LEVEL-01 TO LEVEL-P2 CMU WALL REINFORCEMENT DETAILS

NO.	FOR APPROVAL	DATE	DESCRIPTION	JOB NAME: RYAN COMPANIES RYAN TOWER	
				DATE	DESCRIPTION
0				JOB NO: 22109	DATE: 09-02-22
1				DETAILS OF: LEVEL-01 TO LEVEL-P2 CMU WALL REINFORCEMENT DETAILS	DATE: 09-02-22
2				DETAILER: SSSTR	DRWG: M01
3				TEXAS REBAR, LLC 817-487-1672

C 8" CMU WALL
ELEVATION
 REF: A5.102, A1.101, A3.000, S1.101A, S1.101 & S1.102
 SCALE: 1/4" = 1'-0"

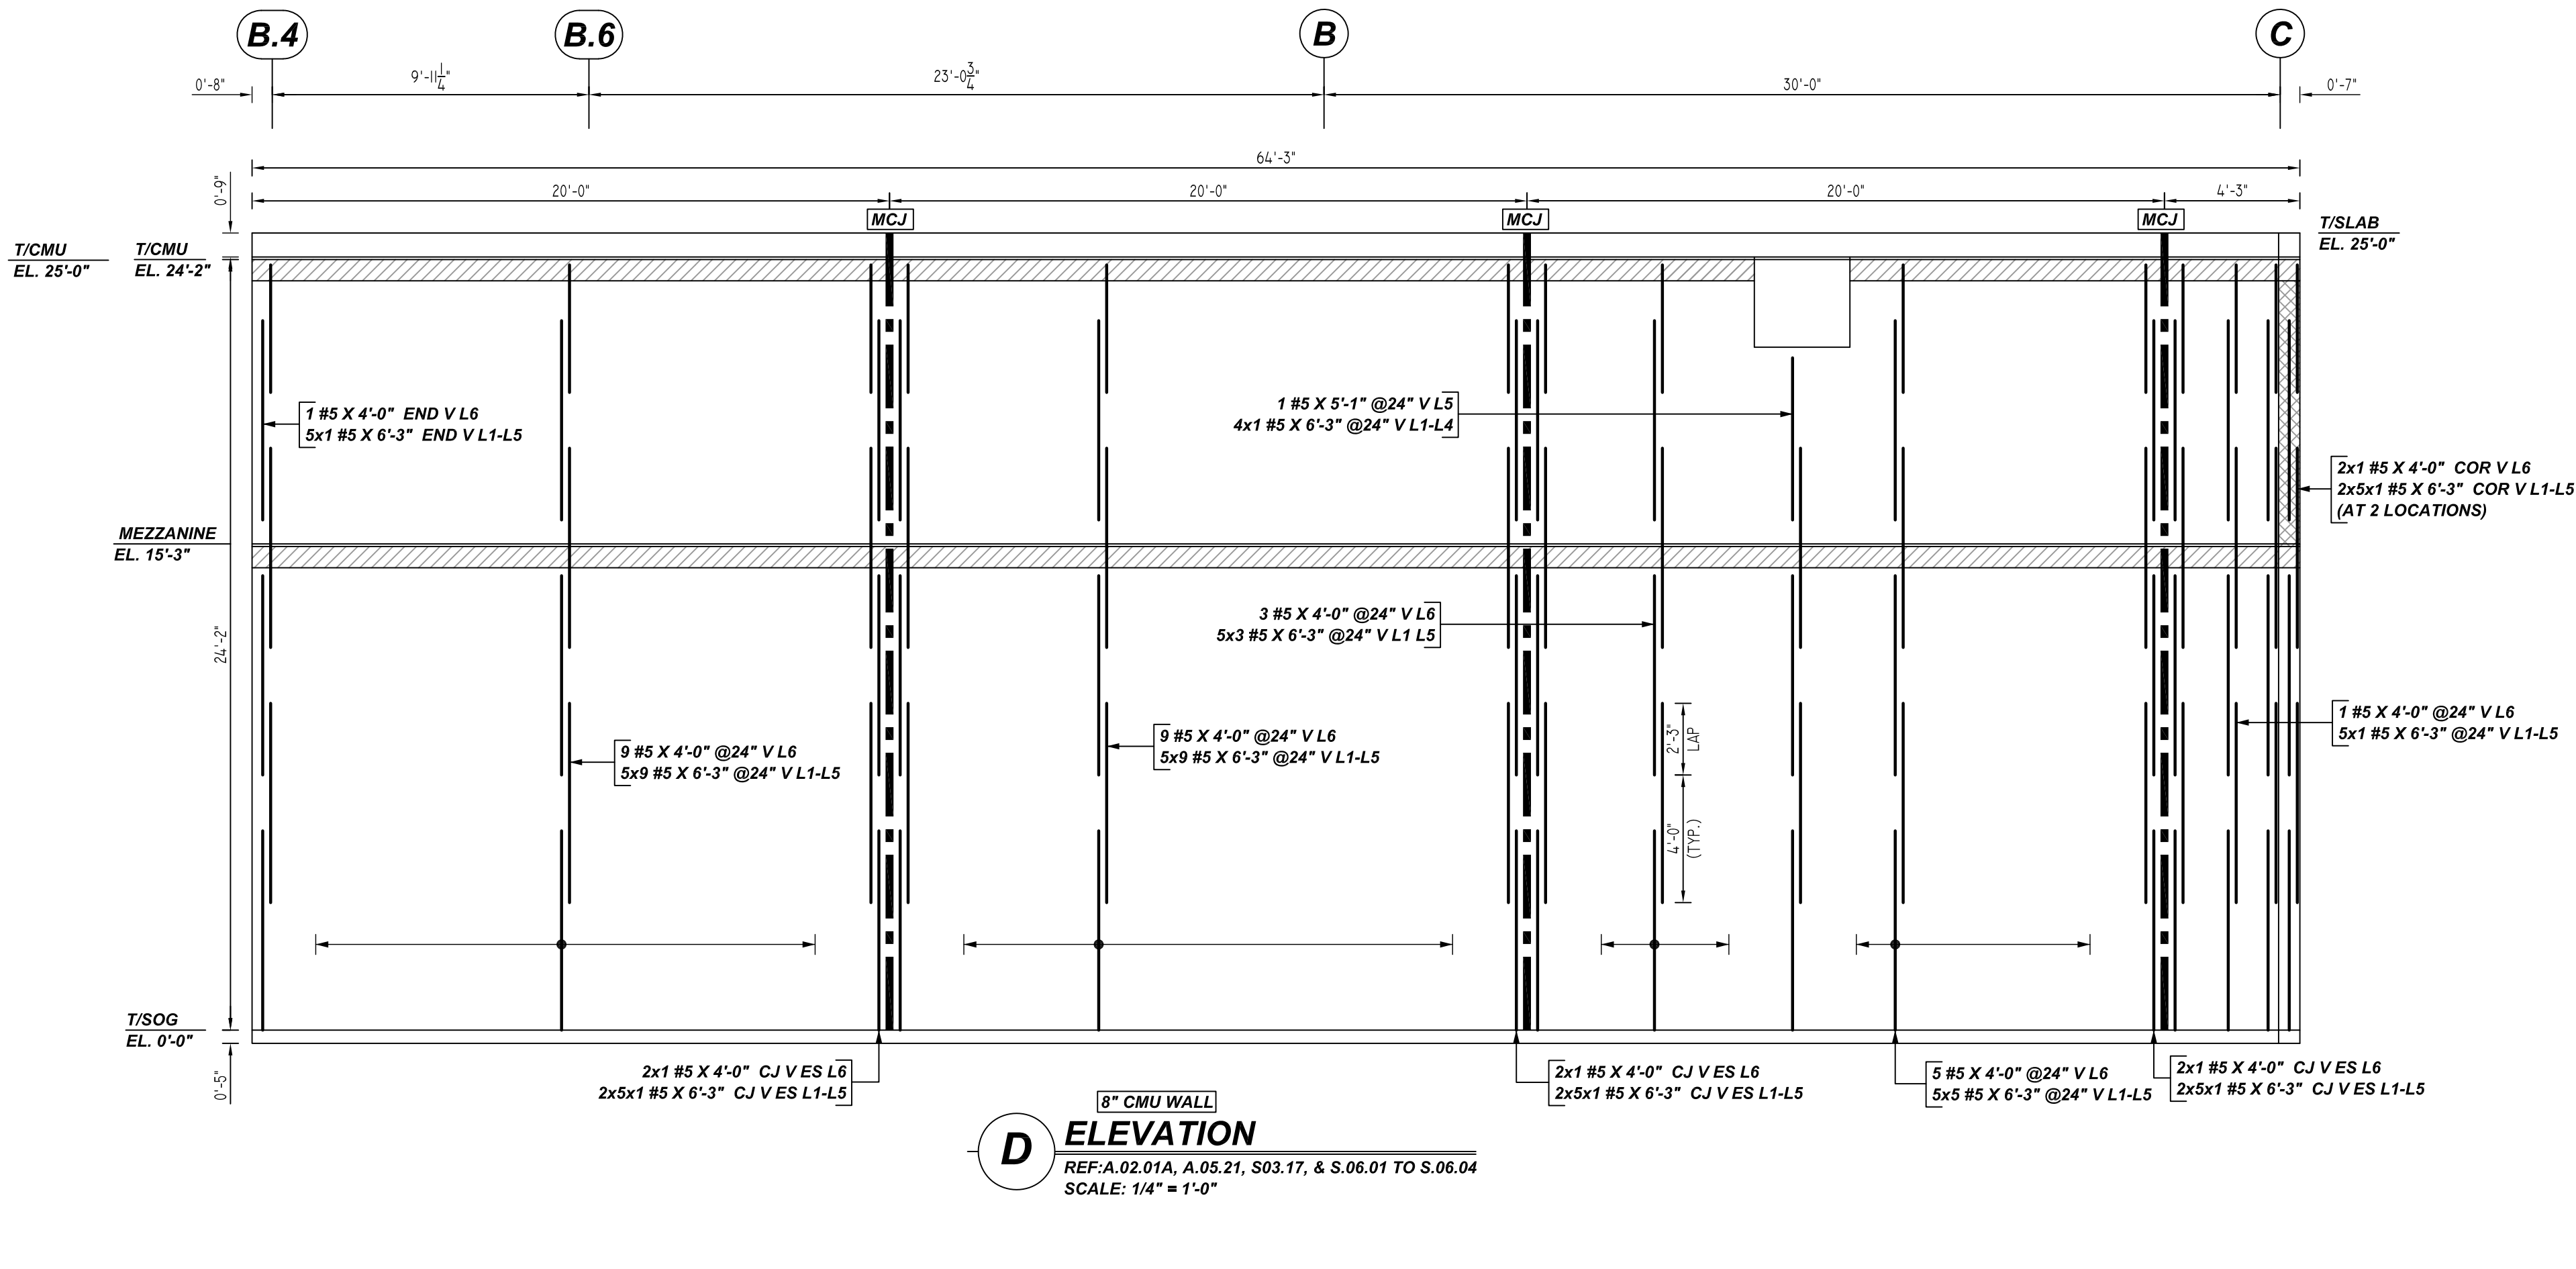
A/E PLEASE VERIFY, THE CJ LOCATIONS WE HAVE FOLLOWED 20'-0" DIMENSIONS (TYP.)
